We request that you amend US Nuclear Regulatory Commission License Number SUC-1593 (docket number 040-9083) to correct the location of the Radiation Control Area at Donnelly Training Area, Fort Wainwright, Alaska.

We have enclosed "M101 Impact Areas," dated February 16, 2018, which should replace a similar document dated December 31, 2015 that is currently incorporated in the license by reference. The only change to "M101 Impact Areas" is the map on page 2.

M101 Impact Areas, February 16, 2018

SUBJECT: Request for Administrative Adjustment to Installation Specific Archive Search
Report on the Use of Cartridge, 20mm Spotting M101 Davy Crockett light Weapon M28 at
Fort Greely, Alaska, October 2008

Overlay of Historic maps from 1962 and 1975 with annotated coordinates

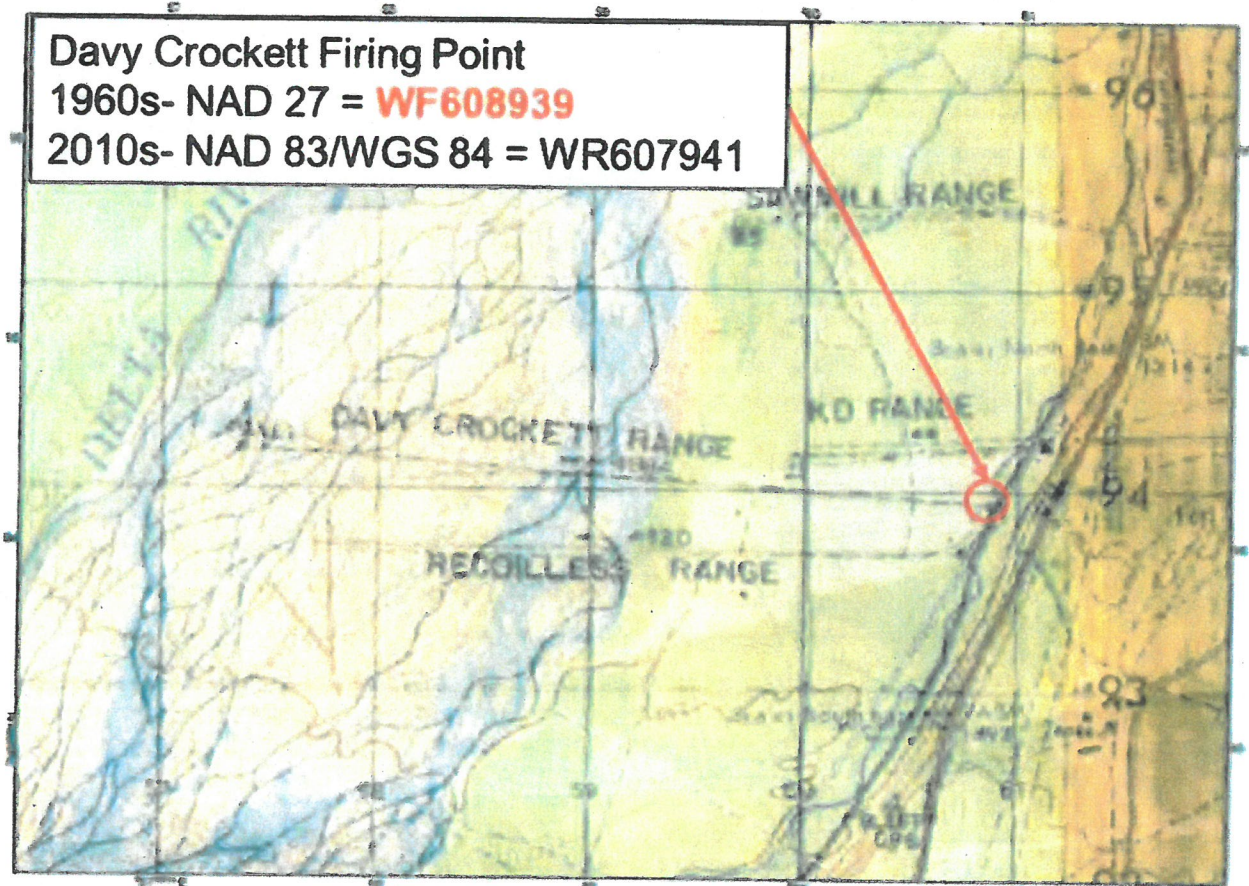
g. Enclosure 7 is a correlation of the two map references (Enclosure 4 & 5) and a plot of the firing point grid from the Land Use Study (Enclosure 6). All three references are based on the NAD27 map datum. As shown on the map the grid called out in the land use study matches the plot of the firing point on the map.

NOTE: This picture is a graphical overlay of the 1962 and 1975 maps and then using the information from the Land Use Report plotting the actual location of the firing point for the Davy Crockett Range. This used three separate data points to confirm the location. The grid coordinate was then converted from the original map datum (NAD27) to the current map Datum (NAD83/WGS84).

Photograph taken from the Installation Specific ASR – Fort Greely, Cartridge, 20mm Spotting M101, Davy Crockett Light Weapon M28, Figure 7, page 12.

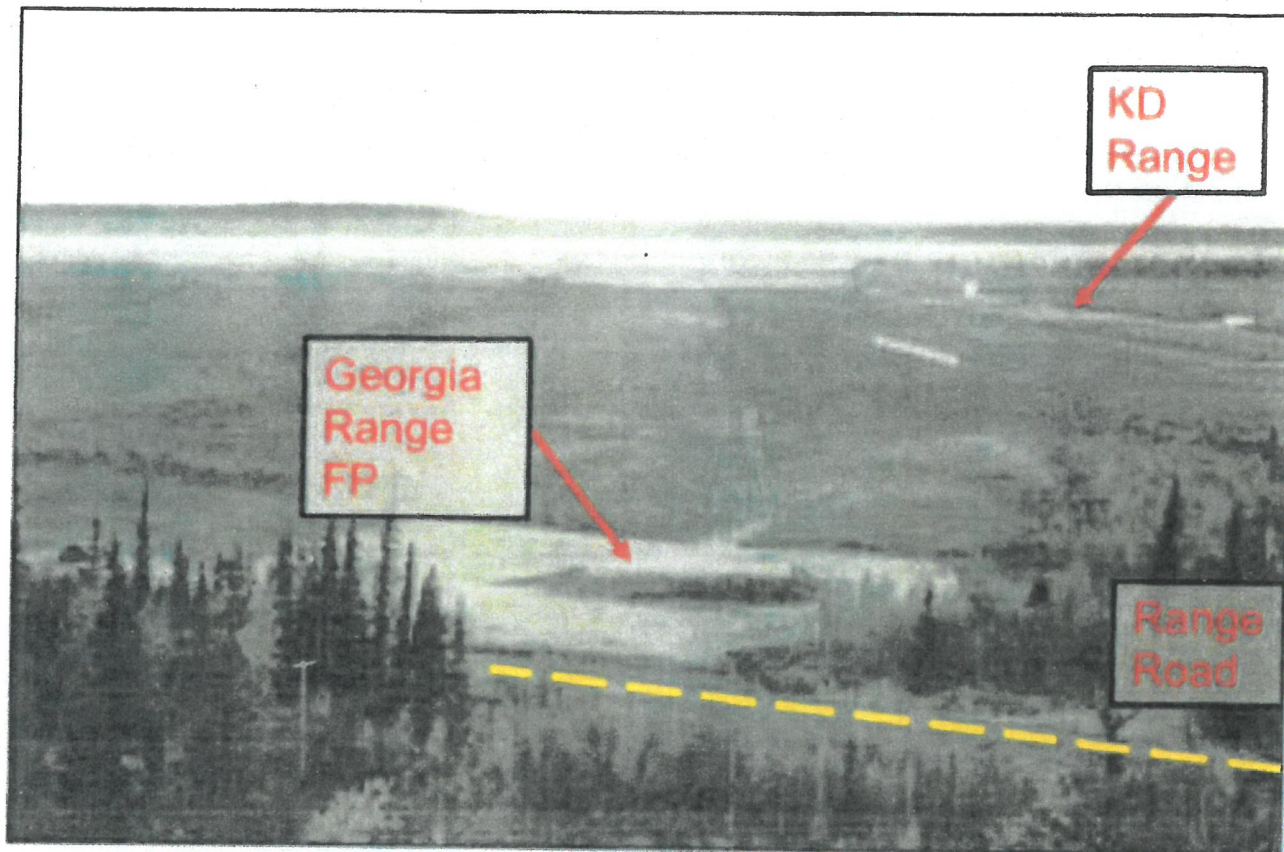
e. The mapped location of the firing point in the final report has it located to the East of the Range Road. The picture at Enclosure 8 (taken from Figure 7 of the report) clearly shows the firing point to the West of the road.

h. Enclosure 8 is a historical photo of Georgia Range. It appears in Figure 7 and Figure 9 of the report. The picture has been annotated with some key terrain features to assist in geo-referencing this to maps and other imagery. This picture clearly shows that the firing point is on the West side of the Range Road.

NOTE: Annotations were added to the picture to provide clarity on what is seen in the picture. The locations of the firing point in relation to the KD Range, as described in the Land Use Study, is correlated with this photo. Again, note that the firing point is on the West side of the Range Road.

Extract from Plate 4 from the report – Annotated with documented reference points

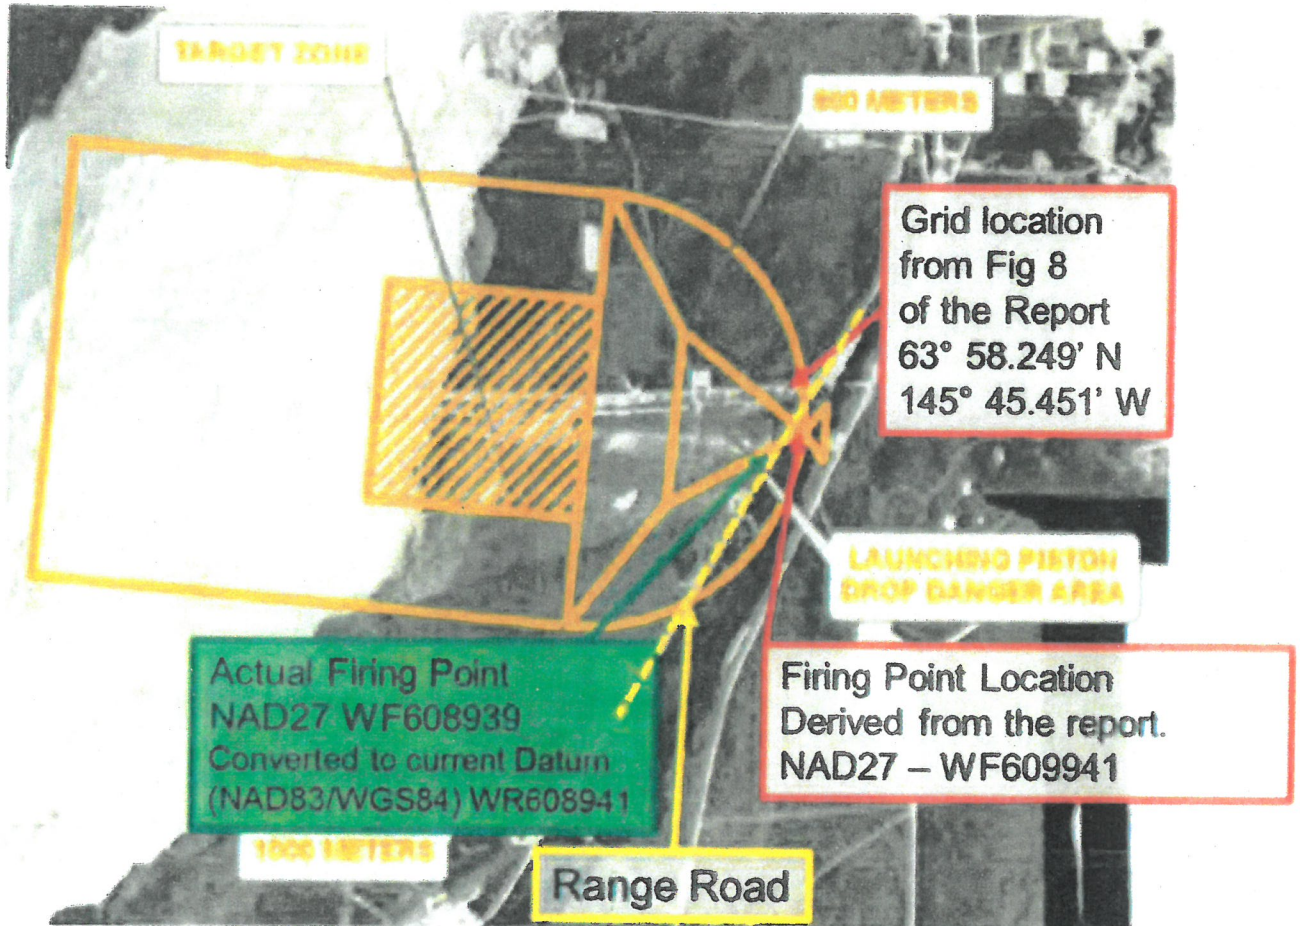
f. The plot of the firing point on the map in Figure 6 (and Appendix I-7) in the report does not correlate to the Surface Danger Area Diagram as plotted on Plate 4 in Appendix I of the report.

j. Enclosure 10 is an extract from Plate 4 of the report. Using geo-referencing we have plotted several key points. First is the grid location based on the picture in Figure 8, this clearly plots on the KD Range. The second location is the plotted location of the firing point contained in the report and used in determining the potentially contaminated area. Third, is the actual location of the firing point based on the Land Use Study.

NOTE: Based on ortho-correcting the imagery and geo-referencing them with the map information from the time of the range we were able to derive the actual location for the firing point. The actual firing point is over 200 meters away, further to the South and West from what is currently in the report

Comparison of Surface Danger Area Diagrams (SDAD) for both locations

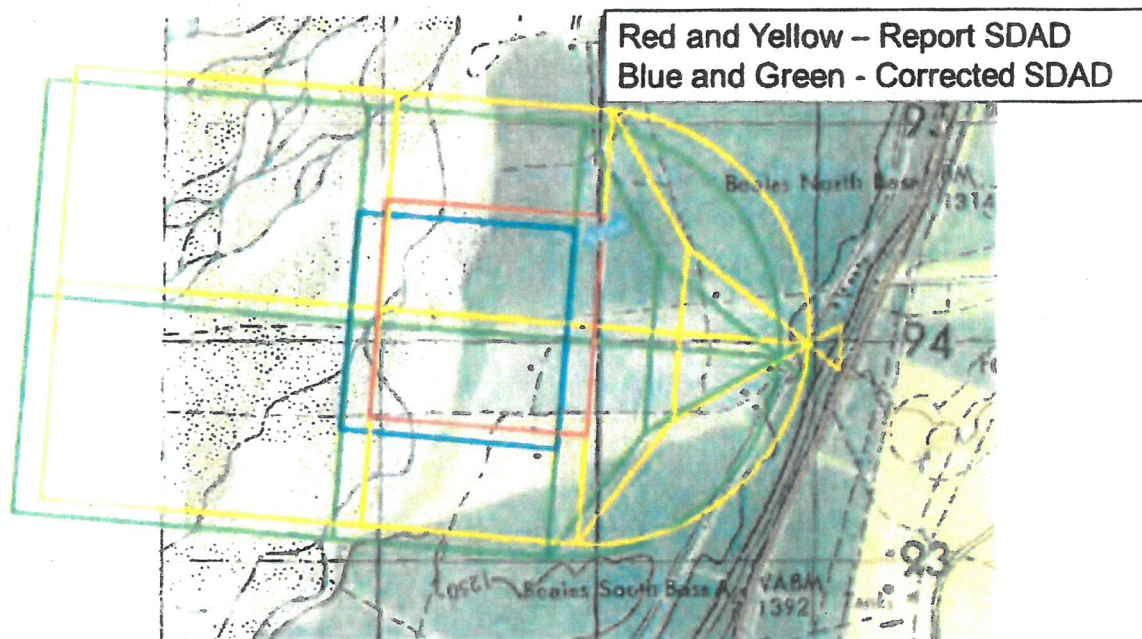
k. Enclosure 11 is a comparison of the SDAD plot contained in the original report and the corrected plot based on the additional information and our GIS analysis.

NOTE: The diagram in yellow with the red target area box is from the original report.
The diagram in green with the blue target box area depicts the corrected location.

The corrected SDAD geo-referenced to 2015 imagery.

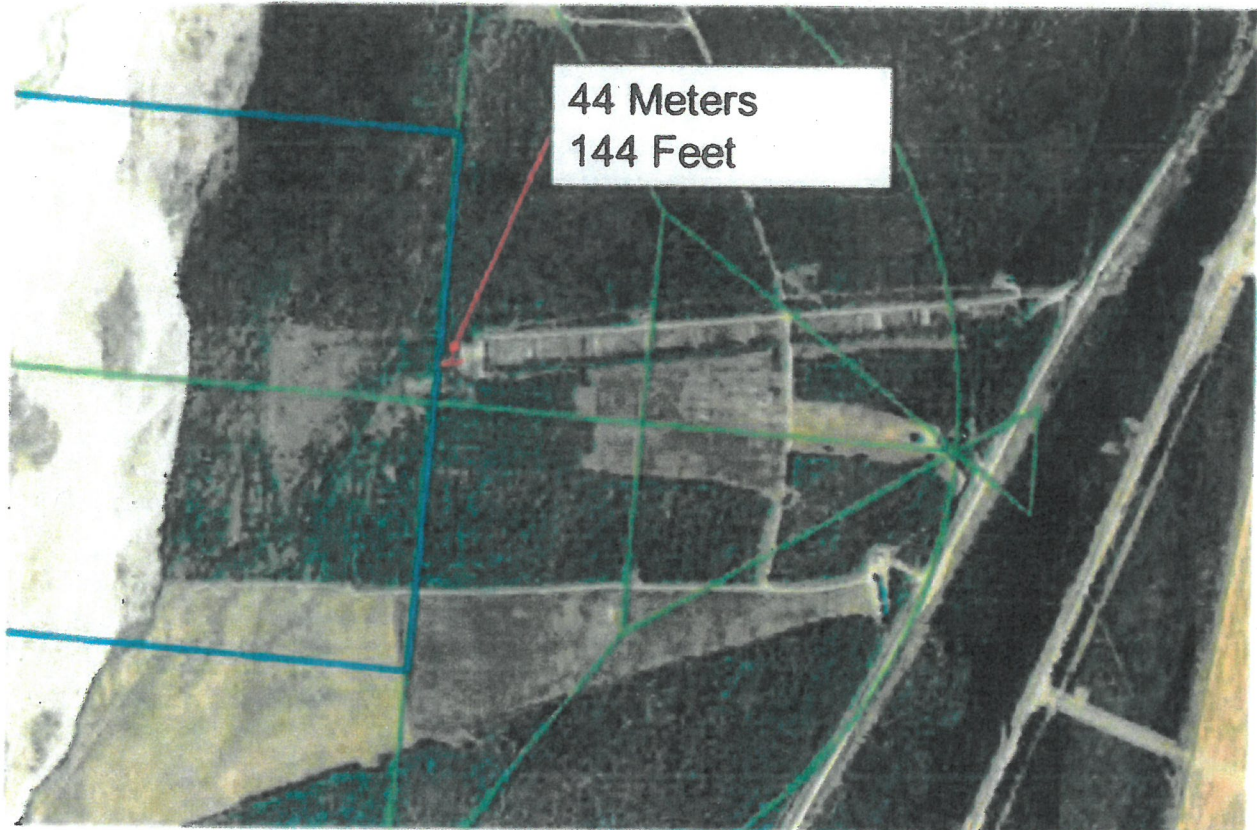
l. Enclosure 12 is a close up view of the corrected SDAD overlaid on the most current imagery. This show that the current location of the KD range DOES NOT fall within the designated DU target area.

NOTE: The corrected SDAD shifts the eastern edge of the target box to the West. As a result the closest point of the target box to the KD range is 144 ft west of the end of the KD Range.

The corrected SDAD overlaid on the original 1962 map.

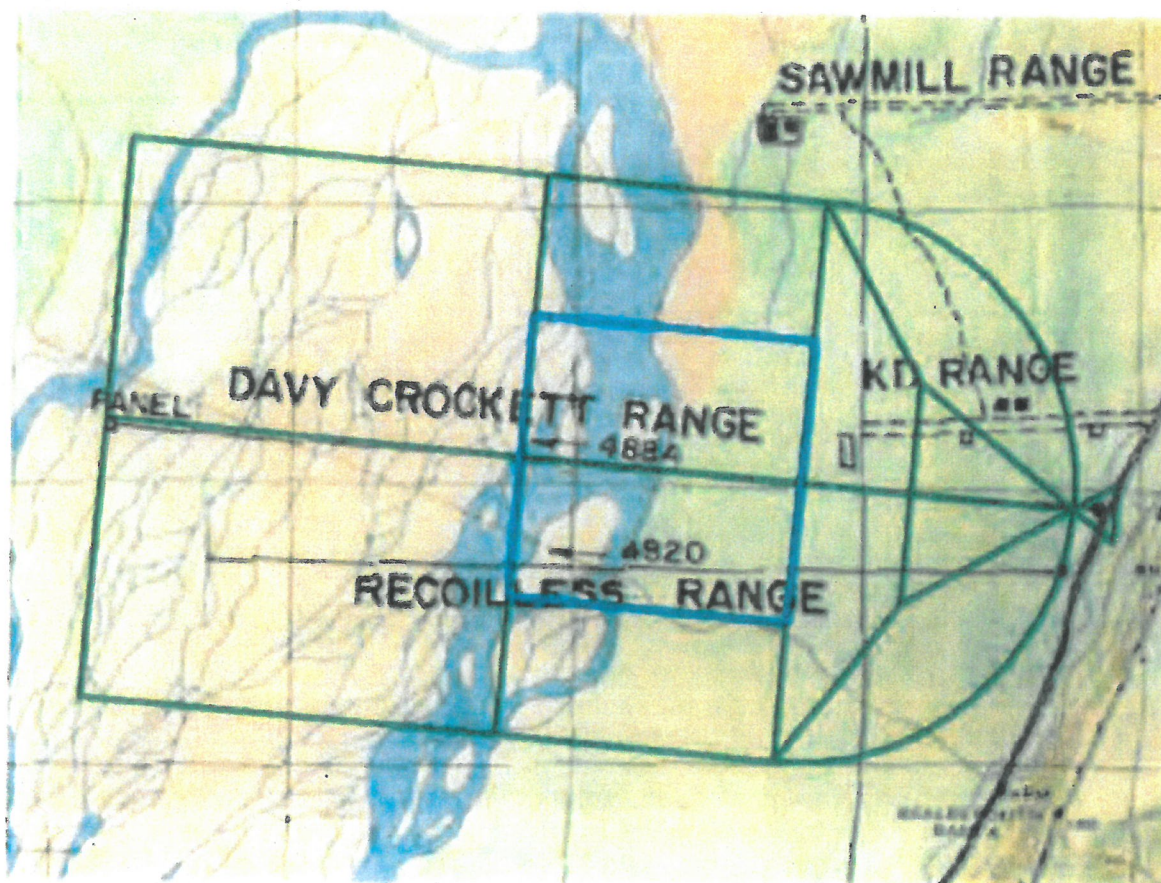
m. Enclosure 13 is a geo-referenced plot of the corrected SDAD over the 1962 map plot for the range. This shows an almost perfect correlation with the corrected SDAD.

NOTE: This diagram is a plot of the corrected SDAD and the original map plot of the range in 1962. This validates the corrected SDAD as being true and accurate based on all information gathered.

REVISION TO PLATE 2

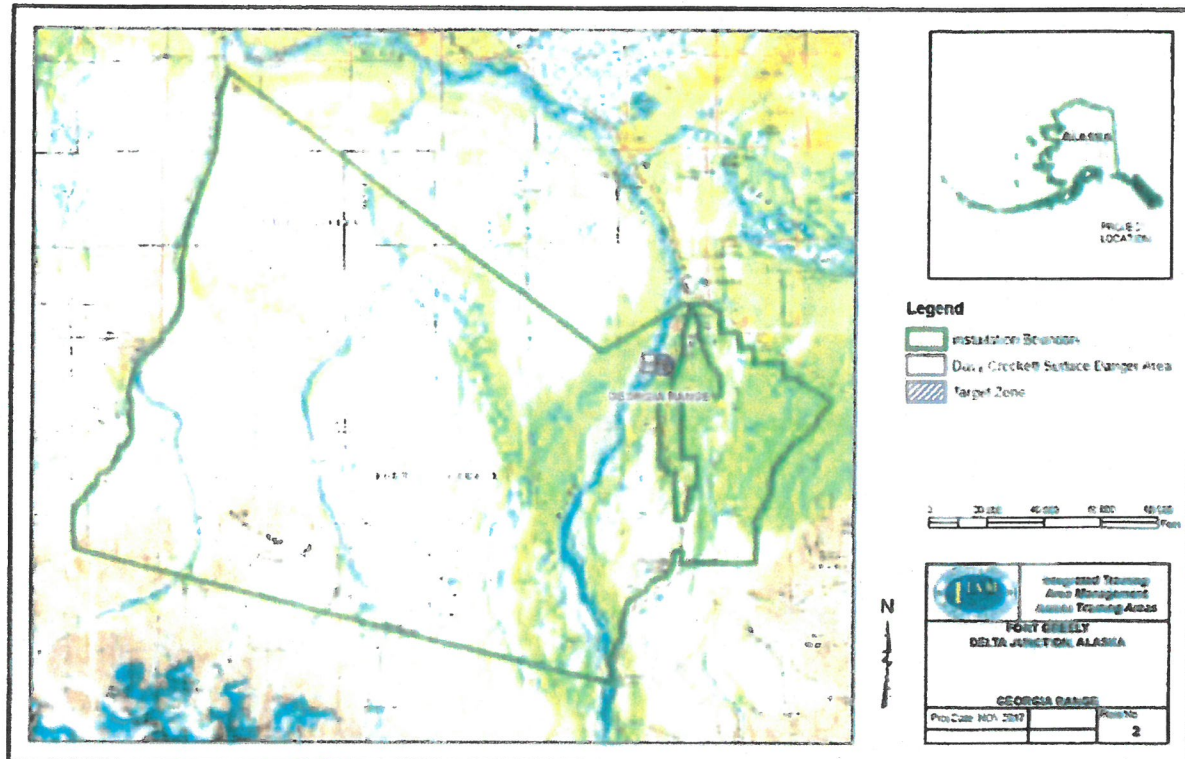
n. Enclosures 14 – 19 are the revisions to the plates in Appendix I of the report based on the corrected version of the SDAD. The specific changes to the LAT/LONG for the corrected box are listed as well as on the diagram.

REVISION TO PLATE 6

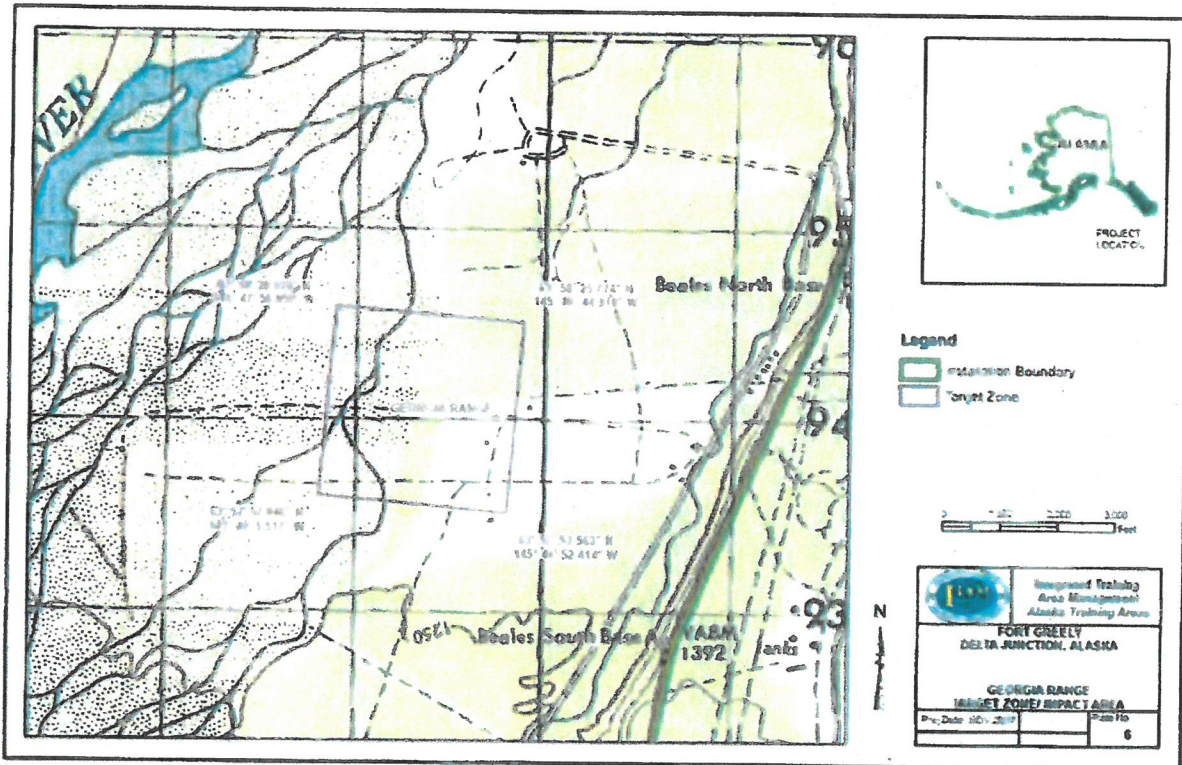
4. Recommendation. Recommend approval of the corrected location of the Target Zone/Impact Area (Enclosure 1) as currently recorded Appendix I, Plate #6, as well as corrections to other figures and plates described in the attached technical report.

POSITION	ORIGINAL REPORT (OCT 2008)		REQUESTED CORRECTION	
	LATITUDE	LONGITUDE	LATITUDE	LONGITUDE
NW	63° 58' 30.561" N	145° 47' 48.533" W	63° 58' 28.976" N	145° 47' 58.059" W
NE	63° 58' 27.721" N	145° 46' 35.305" W	63° 58' 25.774" N	145° 46' 44.910" W
SE	63° 57' 55.475" N	145° 46' 41.983" W	63° 57' 53.563" N	145° 46' 52.414" W
SW	63° 57' 58.596" N	145° 47' 55.171" W	63° 57' 57.046" N	145° 48' 5.517" W
